APPLICATION NO.	FILING DATE	FIRST NAMED INVENTOR	ATTORNEY DOCKET NO.	CONFIRMATION NO.
10/616,269	07/08/2003	Anup K. Sharma	SUNMP227	1695
32291	7590	04/27/2006	EXAMINER	
MARTINE PENILLA & GENCARELLA, LLP 710 LAKEWAY DRIVE SUITE 200 SUNNYVALE, CA 94085			CHAUDRY, MUJTABA M	
			ART UNIT	PAPER NUMBER
			2133

Office Action Summary	Application No. 10/616,269	Applicant(s) SHARMA ET AL.	
	Examiner Mujtaba K. Chaudry	Art Unit 2133

DETAILED ACTION

Fig. 4

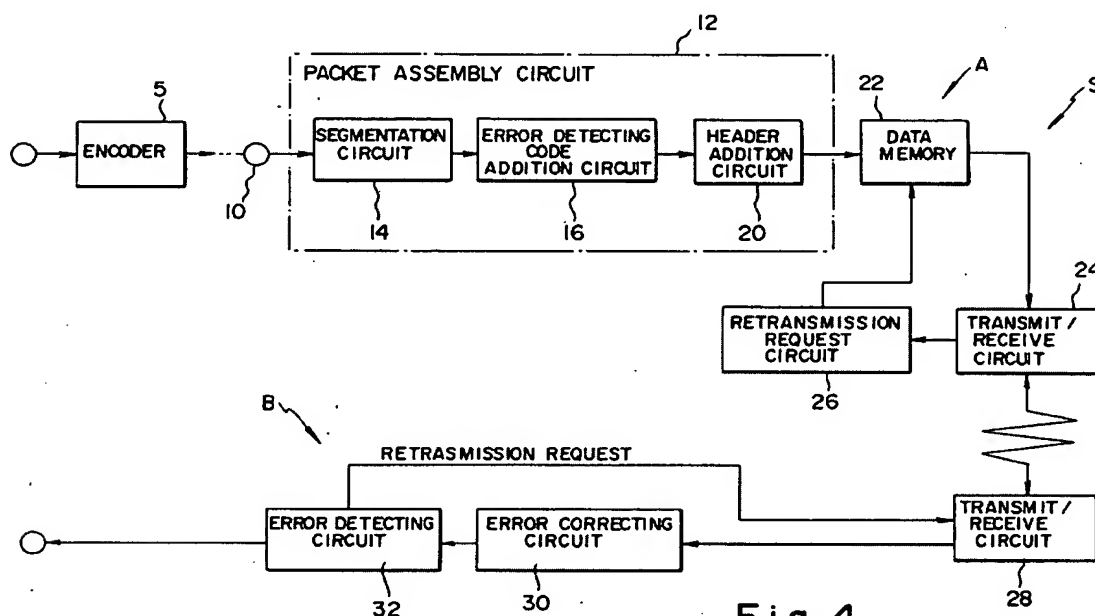
Applicant contends, "...prior art of record does not teach or suggest a point region configured to indicated an address of the data packet in the memory and transmitting the signal to the pointer region for retransmission of the data packet..." The Examiner respectfully disagrees. A **packet** is defined as a group of data bits which usually consist of header containing control information such as a sequence number, the network address of the station that originated the packet and the network address of the packet's destination. A **pointer** is defined as an identifier that indicates the address or storage location of an data item. Kato clearly teaches, Figure 4 for example, a packet assembly circuit 12 which appends header control information to

the header by the header addition circuit 20. Therefore the packets transmitted, as taught by Kato, inherently have to have pointer region or header portion of the packet so that the packet is arrived at the appropriate destination and able be requested for retransmission if so needed. See Figure 4, Kato:

Fig. 4

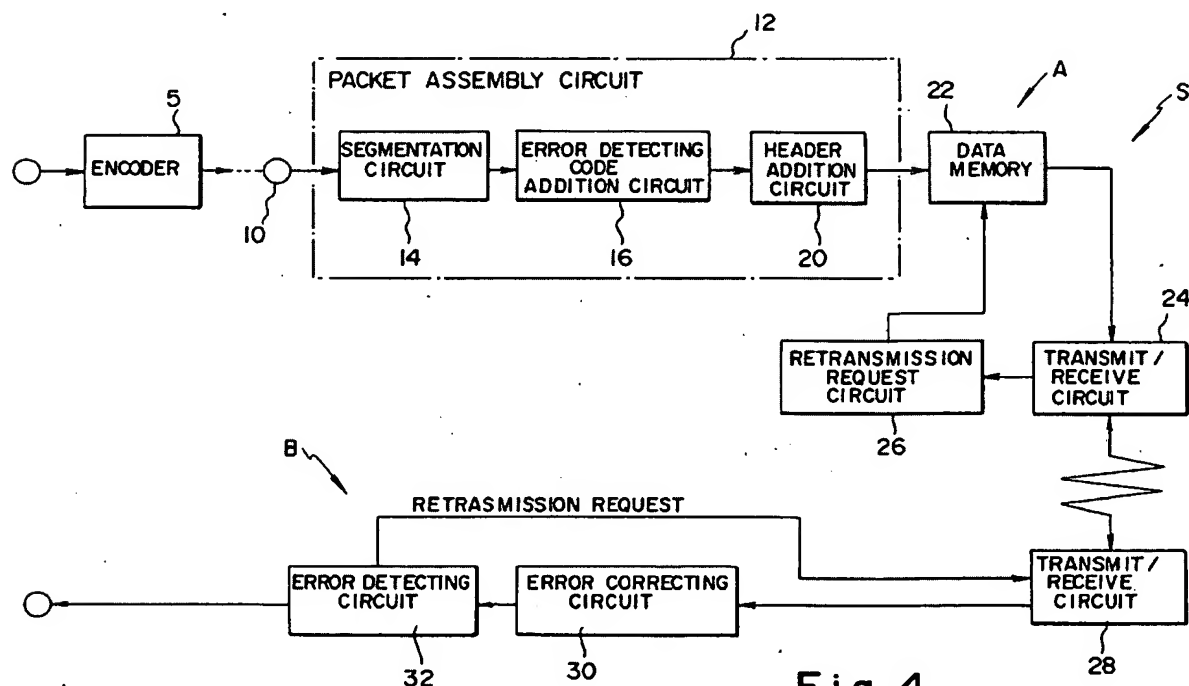
As per claim 1, Kato substantially teaches (abstract) an error correcting code including of basic data and a BCH-based parity code appended thereto is divided into smaller packets. An error detecting code is appended to each of the thus-divided packets, so that transmission basic data is formed. When the transmission basic data is received, the basic data and a BCH-based parity code are derived from the transmission basic data. Error correcting is carried out with respect to the overall transmission basic data. An error detecting operation is carried out with respect to each packet using the error detecting code. If a packet is found to contain errors, a request for retransmission of that packet will be sent to the sending side. In particular, Kato teaches (Figure 4) a communication system with all the essentials of the present application.

Kato does not explicitly teach transmitting the data from a first microprocessor to a second microprocessor as stated in the present application.

However, Kato does teach (Figure 4) a communication system which comprises of a transmitter and receiver. The Examiner would like to point out that it is well known in the art that it is inherent for transmitters and receivers to have microprocessors. AAPA also teaches (pages 1-2 and Figure 1) a communication of two microprocessors. Therefore it would have been obvious to one of ordinary skill in the art at the time the invention was made to modify the teachings of Kato by implementing the communications between two microprocessors. This modification would have been to one of ordinary skill in the art because one of ordinary would have recognized that the communication system in the teachings of Kato and the environment of AAPA are compatible and would have been an efficient way of transmitting digital data from a source A to destination B.

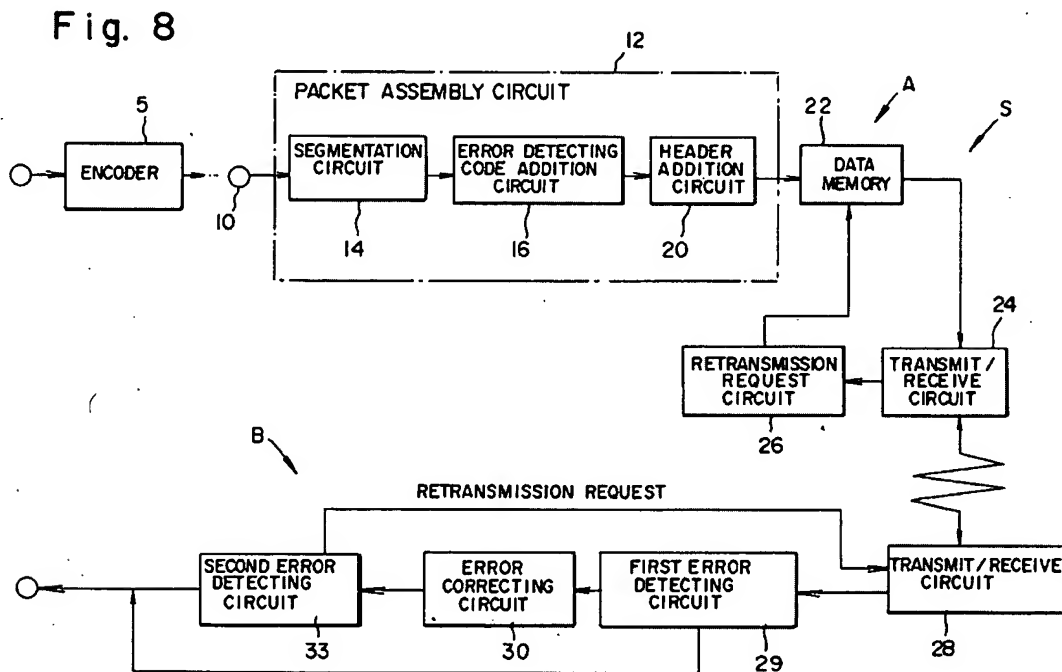
As per claim 7, Kato substantially teaches (abstract) an error correcting code including of basic data and a BCH-based parity code appended thereto is divided into smaller packets. An error detecting code is appended to each of the thus-divided packets, so that transmission basic data is formed. When the transmission basic data is received, the basic data and a BCH-based parity code are derived from the transmission basic data. Error correcting is carried out with respect to the overall transmission basic data. An error detecting operation is carried out with respect to each packet using the error detecting code. If a packet is found to contain errors, a request for retransmission of that packet will be sent to the sending side. In particular, Kato teaches (Figure.4) a communication system with all the essentials of the present application.

Kato does not explicitly teach transmitting the data from a first microprocessor to a second microprocessor as stated in the present application.

However, Kato does teach (Figure 4) a communication system which comprises of a transmitter and receiver. The Examiner would like to point out that it is well known in the art that it is inherent for transmitters and receivers to have microprocessors. AAPA also teaches (pages 1-2 and Figure 1) a communication of two microprocessors. Therefore it would have been obvious to one of ordinary skill in the art at the time the invention was made to modify the teachings of Kato by implementing the communications between two microprocessors. This
